SUBJECT: Forwards response to NRC 791024 ltr re dedicated safe shutdown sys. Onsite power supply & possible new or rerouted bus work undergoing engineering analysis. Final design will be submitted by 800301.

H. B. ROBINSON STEAM ELECTRIC PLANT, UNIT NO. 2

RESPONSE TO QUESTIONS REGARDING SAFE SHUTDOWN CAPABILITY

The attached correspondence contains CP&L's response to information requested in your October 24, 1979 letter titled "Staff Position-Safe Shutdown Capability" concerning the Robinson dedicated shutdown system.

FIGURE 2
STEAM DRIVEN FWP STEAM SHUTOFF VALVE V1-8A

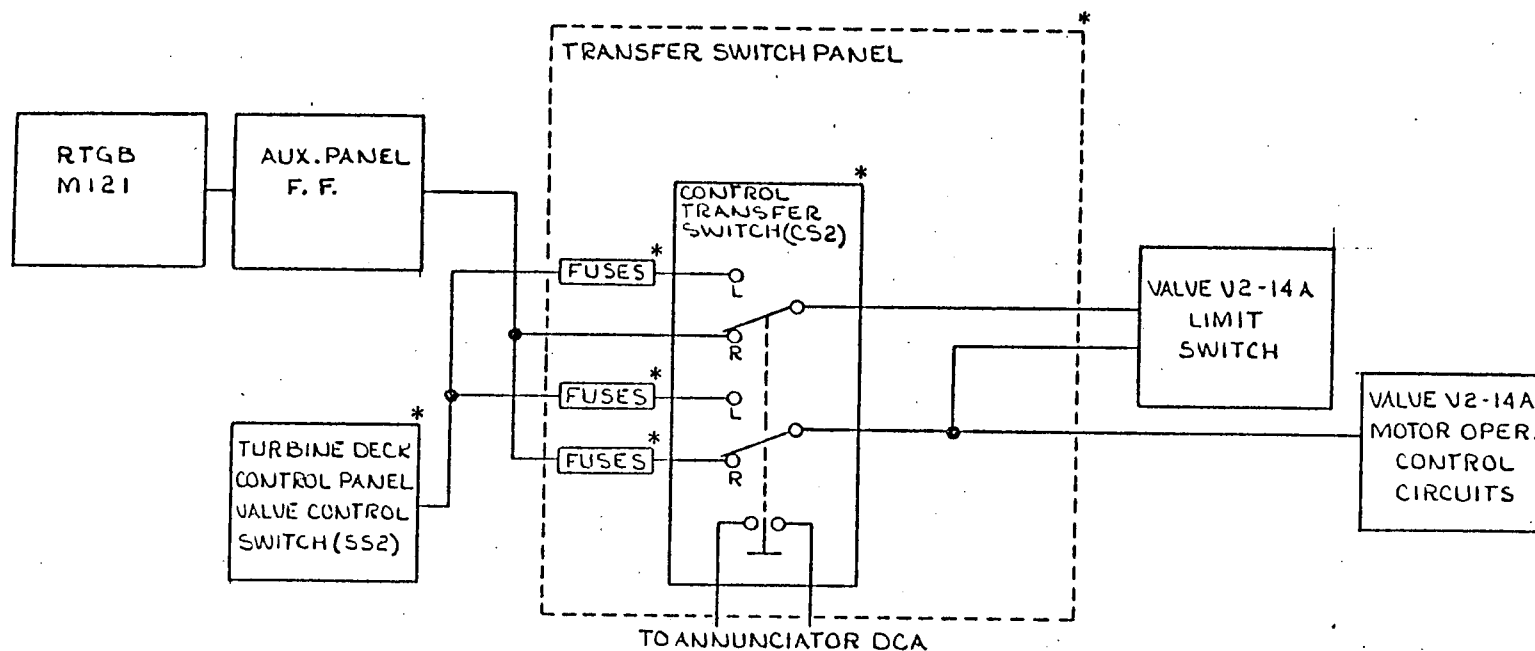
Steam Driven Feedwater Pump Shutoff Valves V1-8A and V2-14A

Figures 2 and 3 are simplified control diagrams for these two valves. Transfer switches have been provided on a panel in the auxiliary building to transfer control of the valves to a control panel located on the turbine deck. When the transfer switches are moved to the "local" position all control circuits for these valves routed to the main control room or to auxiliary panel "FF" are effectively isolated from the dedicated shutdown circuits and the local control circuits.

In the event that a fire or other event causes a short circuit in the normal (remote) control circuits before the transfer switches are operated, the fuses in these circuits will open before damage can occur in the alternate control systems. These isolation fuses are coordinated with the fuses in the valve motor operator control circuits to ensure that the control power supply fuses do not open due to faults in the remote control cables. Additional fuses have been provided in the transfer switch panel to ensure that the motor operator control circuits are not damaged by faults in the local control circuits at the turbine deck control panel.

FIGURE 4
STEAM DUMP VALVE CONTROL

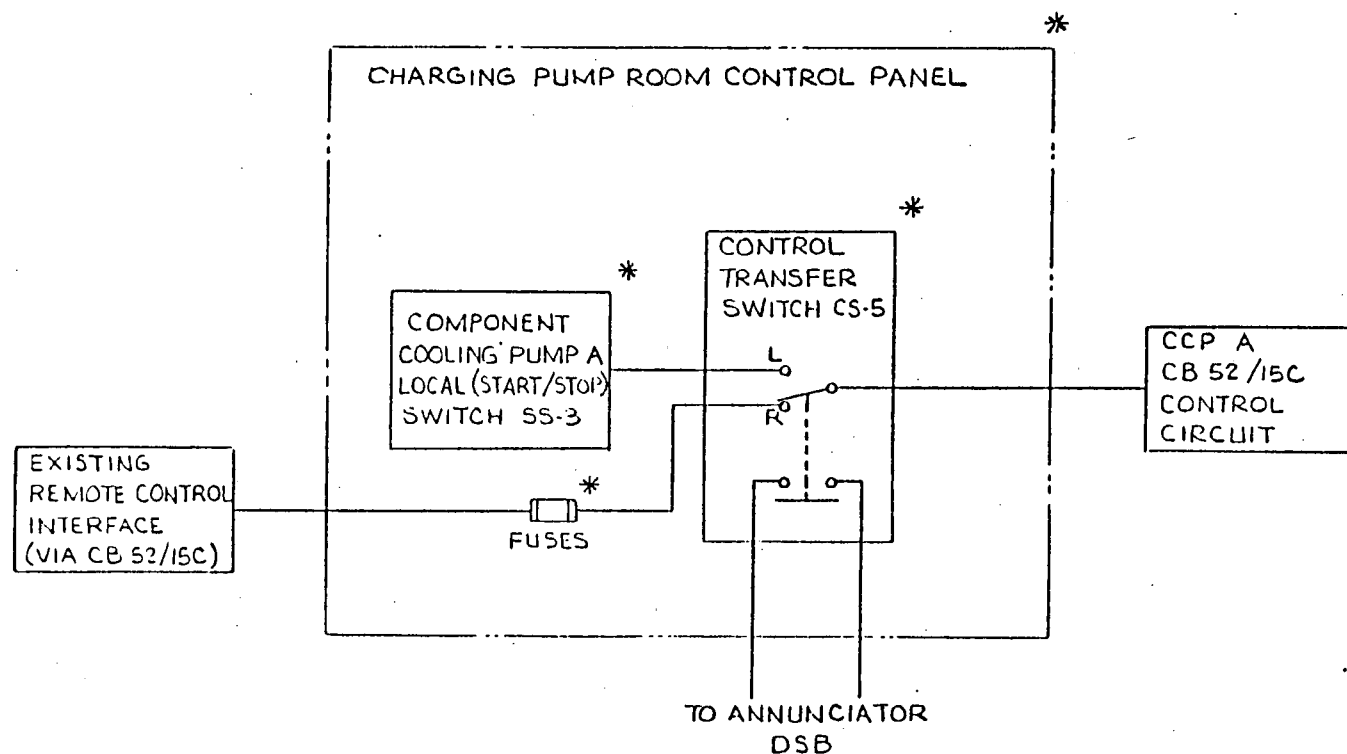
Power-Operated Relief Valves

The turbine deck control panel also provides for disabling the existing remote control of steam generator power-operated relief valves RV1-1, RV1-2, and RV1-3; Figure 4 is a simplified diagram of the control transfer. When transferred to local control, the valves can be operated by using the existing valve controllers located on the turbine deck. The transfer to local control is annunciated in the Control Room.

FIGURE 5
COMPONENT COOLING PUMP A CONTROL TRANSFER

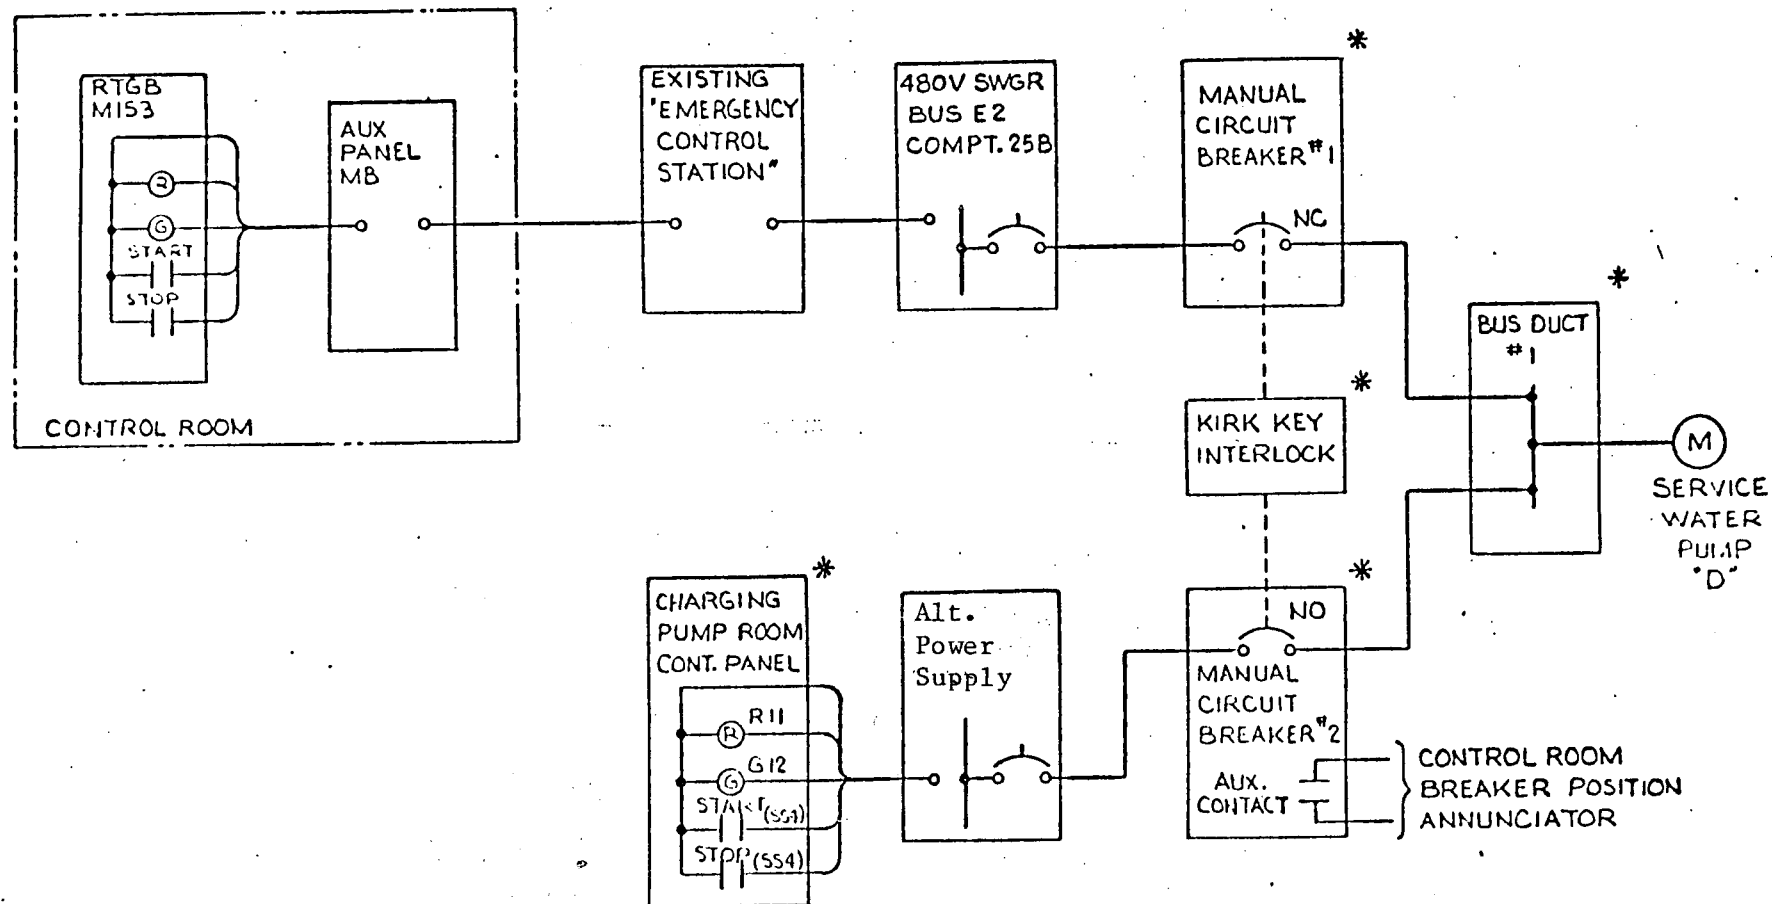
Component Cooling Pump A

A transfer switch is provided on the charging pump room control panel to disable the existing remote control of component cooling pump (CCP) A and to transfer control of the pump to a local switch on the panel. Figure 5 is a simplified diagram of the control transfer scheme. The modification does not change the existing control voltage or power source alignment with the pump. The transfer to local control is annunciated in the main Control Room

Figure 5 is a simplified control diagram for component cooling pump A, showing the isolation devices for the control circuits. The transfer switch and fuses located in the charging pump room panel effectively isolate all circuits required for local control in the event of damage to existing controls in the main control room or the associated cables. The fuses are coordinated with control fuses at the circuit breaker to ensure that the breaker controls remain operative in the event of a fault in the remote control circuits.

FIGURE 7
SERVICE WATER DISCHARGE VALVE V6-12D

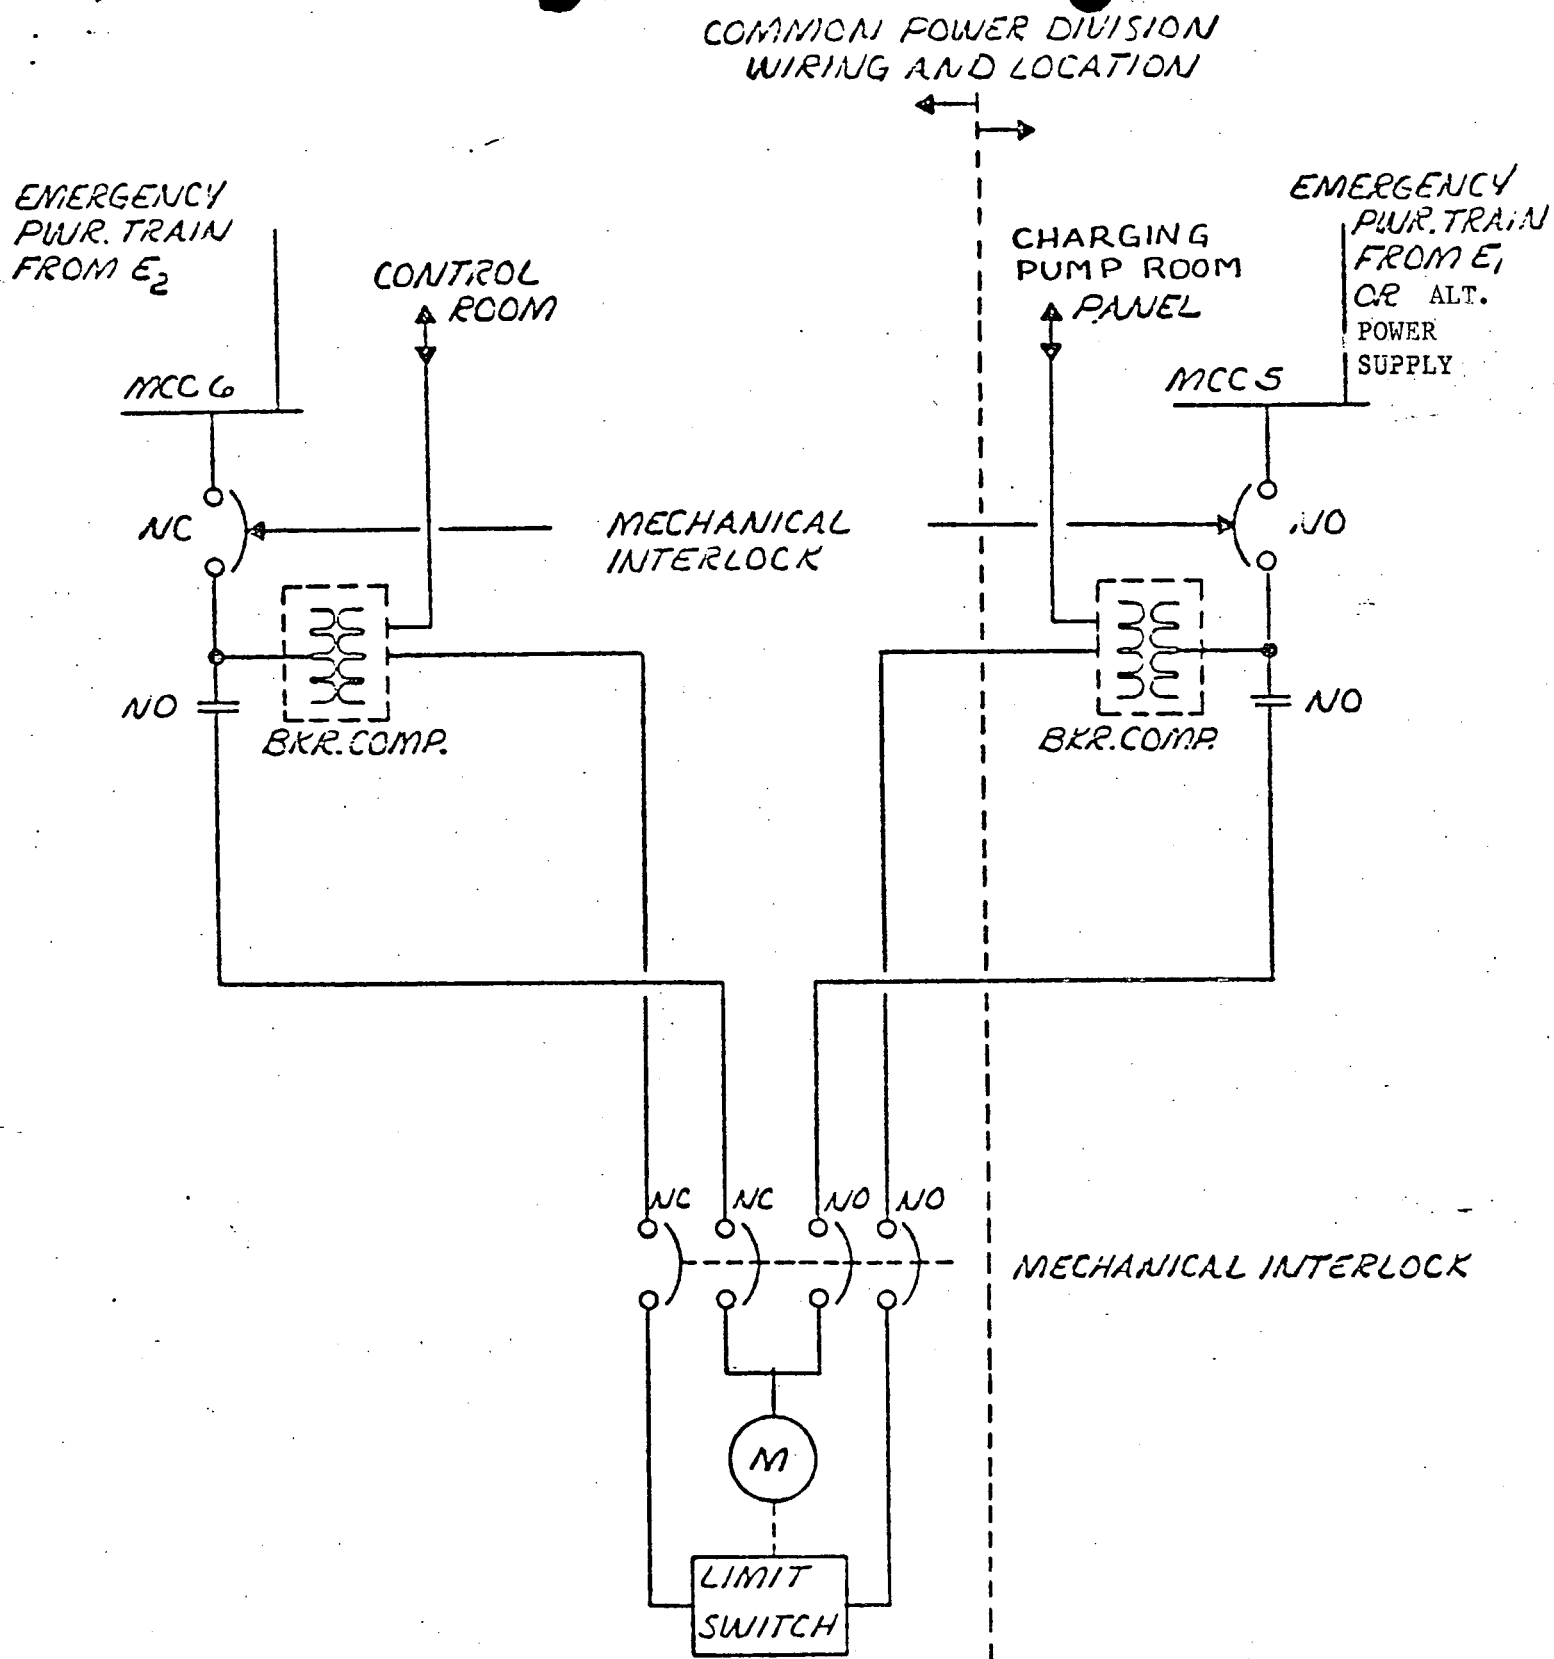
Service Water Discharge Valve V6-12D

Figure 7 shows the control system modification for valve V6-12D. The normal supply for this valve operator is from MCC-6 and control from the main Control Room. The alternate power source and control location is from MCC-5 with a control switch at the charging pump room panel. Isolation of the circuits is accomplished by means of key interlocks of the power supply ACBs in MCC-6 and MCC-5 and the transfer switch which is located inside the auxiliary building. In addition, cables for the main and alternate control circuits are routed in areas remote from each other.

FIGURE 8
CHARGING PUMP "A"

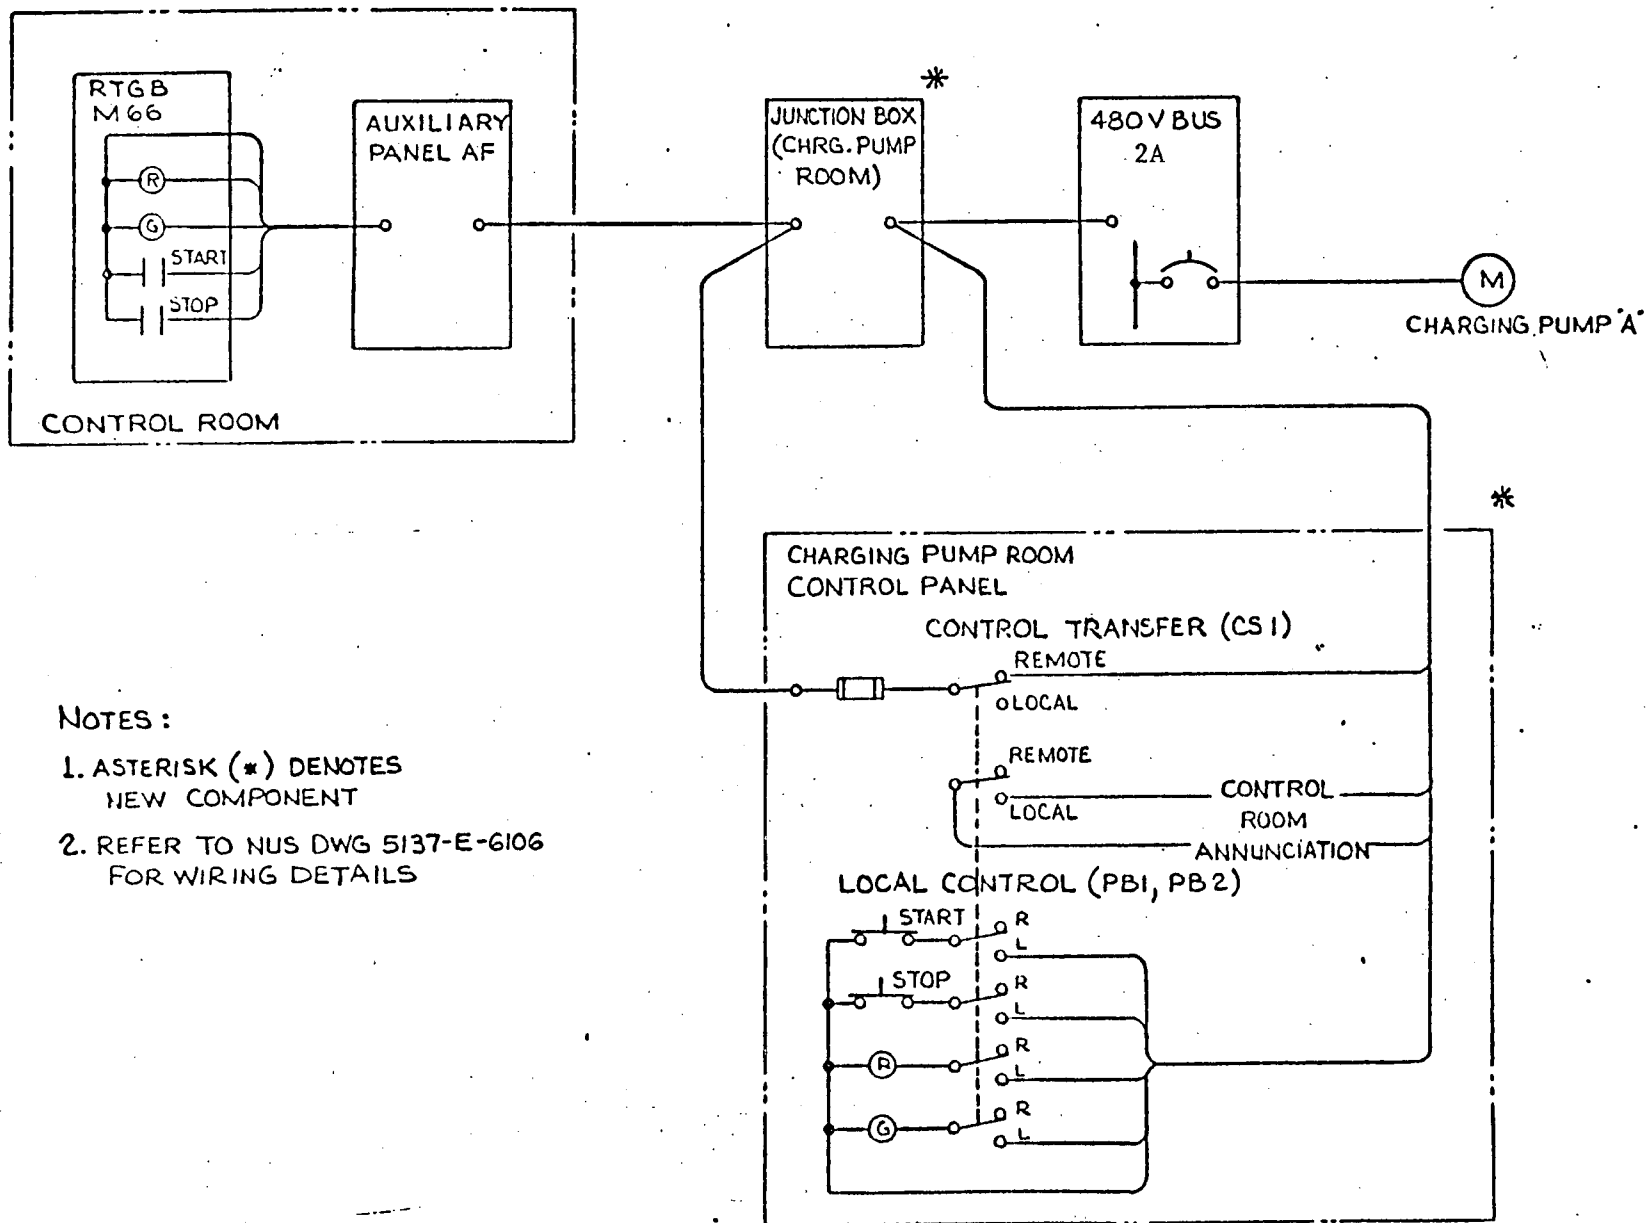
Charging Pump A

The alternate controls for charging pump A, consisting of a control transfer switch and pushbutton control switches, are located on the charging pump room control panel. As shown on Figure 8, the pushbutton control switches are electrically functional only when the control transfer switch is in the "local" position. With the control transfer switch in the "local" position, operation of the charging pump A is not affected by any fire in the control, cable spreading, or emergency switchgear rooms.

Figure 8 illustrates the modifications to the existing control circuits for this pump. The alternate control switch is located at the charging pump room panel and the normal remote control circuits are effectively isolated by means of the transfer switch. Coordinated fuses in the remote control circuits will isolate faulted parts of these remote control circuits from the alternate controls before the manual transfer is accomplished.

FIGURE 9
ALTERNATE POWER FOR MCC 5

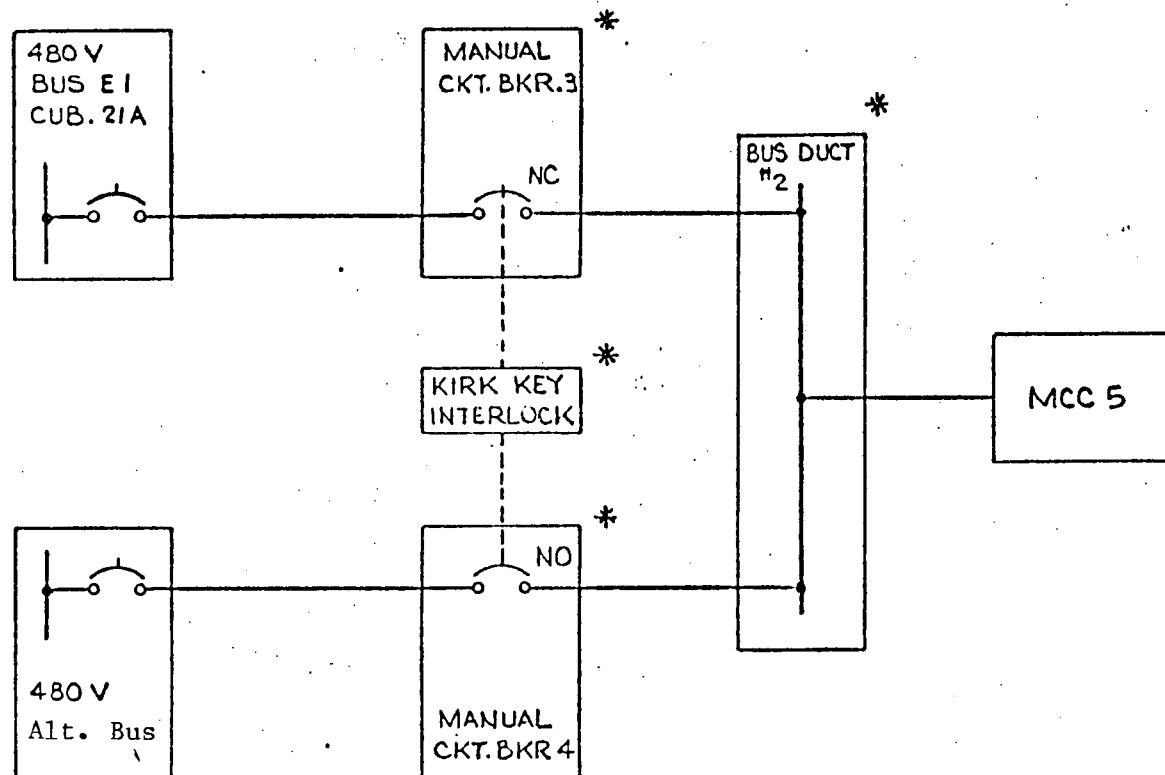
Alternate Power Supply For MCC-5

The normal power supply for MCC-5 is 480V bus E1. To provide a power supply independent of the emergency switchgear room, bus duct 2 and manual circuit breakers 3 and 4 have been installed as shown on Figure 9. The circuit breaker and bus duct configuration is identical to that provided for service water pump "D" (breakers 3 and 4 are also Kirk key interlocked).

By tripping manual circuit breaker 3 and closing manual breaker 4, MCC-5 is supplied from its alternate power supply which is independent of the emergency switchgear, control, and cable spreading rooms. With this breaker alignment, a fire in any of these areas will have no effect on the operation of MCC-5.
